NEDO-31960-A  
Supplement 1  
Class I  
November 1995

**BWR Owners' Group  
Long-Term Stability Solutions  
Licensing Methodology  
(Supplement 1)**

UNITED STATES  
NUCLEAR REGULATORY COMMISSION  
WASHINGTON, D.C. 20555-0001

July 12, 1993

Figure A.5. Comparison between equilibrium-cycle exclusion region and the exclusion region for the specific operating conditions of a BWR/S instability event.

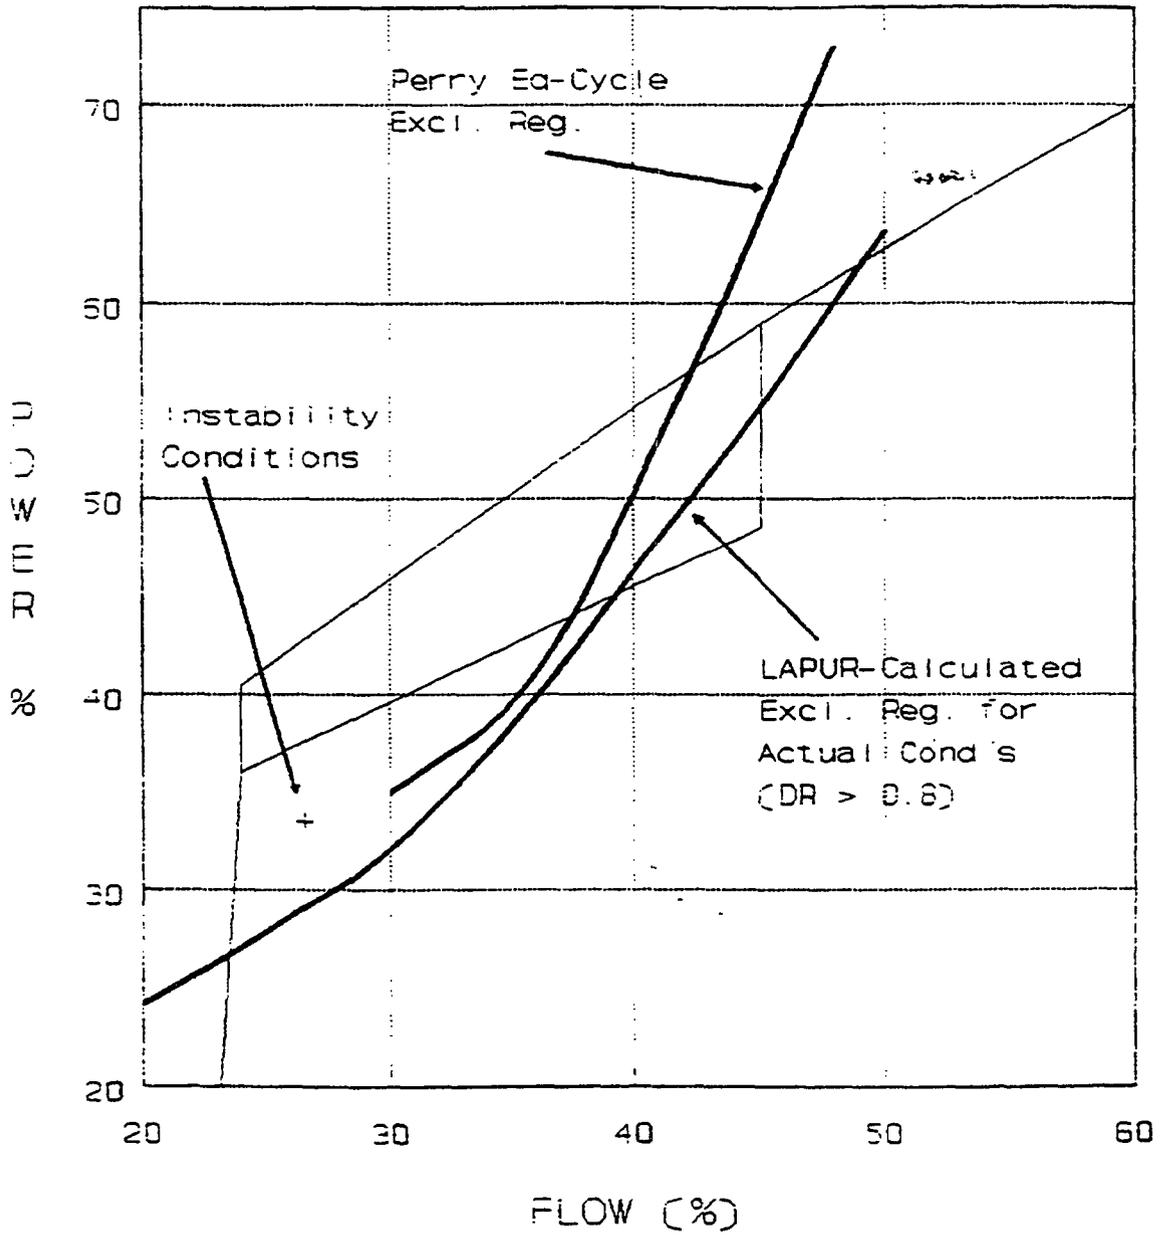
Figure A.5 shows a comparison of the equilibrium-cycle exclusion region for the Perry reactor (a BWR/6) and the exclusion region that results if the actual axial and power shapes from the recent BWR/5 event are used. As it can be observed, the standard BWR/6 exclusion region from NEDO-31960 is not as conservative as the actual region. Therefore, we have recommended that the BWROG must establish a criteria to limit the actual radial and axial peaking factors during startup operations to those values considered for the analyses of the exclusion region. This criteria must be based on parameters or information readily available to the operator in the control room.

Figure 5-1. FABLE/BYPSS Stability Criteria

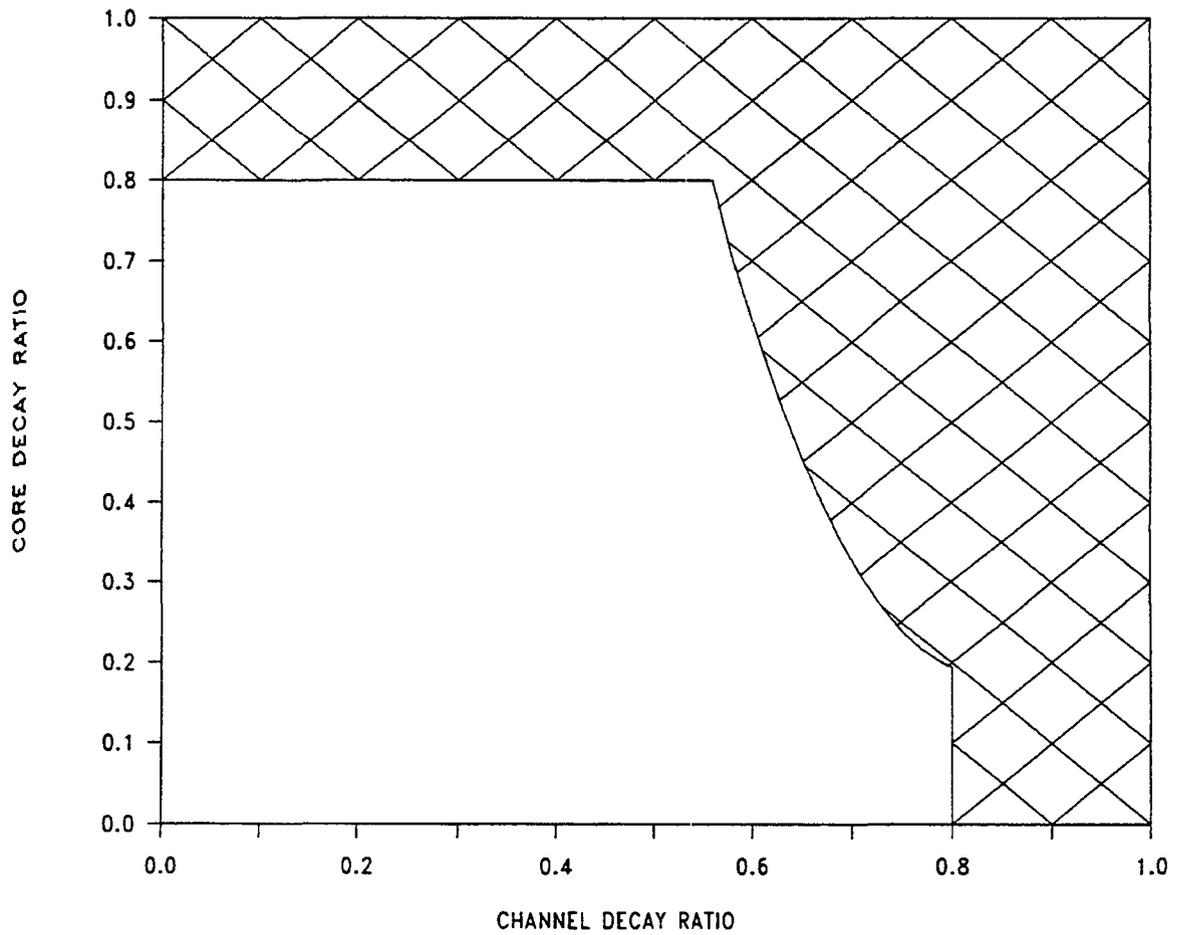
In Section 5.1, "Stability Criteria," a summary description of the acceptance criterion for stability calculations is described. This acceptance criterion is based on Figure 5-4 of NEDO-31960, which is a map of core and channel decay ratio where stability boundaries are defined for in-phase and out-of-phase instabilities. This map was developed with the aid of an unnamed "separate frequency domain code" following a procedure that is vaguely described in the document. The map of Figure 5-4 is the basis for all decay ratio calculations used for Solution I and for Solution III bypass settings. Thus, given its relevance to these results, the qualification of the code used and the procedure followed to define Figure 5-4 deserves more detailed description so that it can be reviewed properly.

In particular, describe which plant conditions were used in the validation, specifically answer whether the eigenvalue separation used for this qualification was bounding for expected operating plants. The curved part of the map should in theory be a function of the eigenvalue separation of the first subcritical mode; thus, specify whether a sufficiently reactive mode is used in the definition of the map of Figure 5-4."

Most of the results of these documents are based on decay ratio calculations that are compared to Figure 5-4. It would be convenient and easier to validate future calculations if Figure 5-4 were expressed in a unique mathematical form instead of in graphical form as it is now. A table of values for the curved part of the figure or a polynomial fit would uniquely define it and make acceptance of calculated decay ratio values an easier task."

The stability criteria shown in Figure 5-4 of Reference 1 (Figure 5-1 of this supplement), and further defined in Table 5-1 of this supplement to Reference 1, were developed based on a combination of post-test evaluations of instability events, theoretical considerations of regional oscillations, and the above-mentioned frequency domain calculations. Section 5.1 of this supplement provides additional details concerning the frequency domain code and the procedure used to estimate regional decay ratios using the code. Section 5.1 also discusses the conditions which were used in developing the stability criteria and concludes that the curved part of the map is representative of a sufficiently reactive harmonic mode.
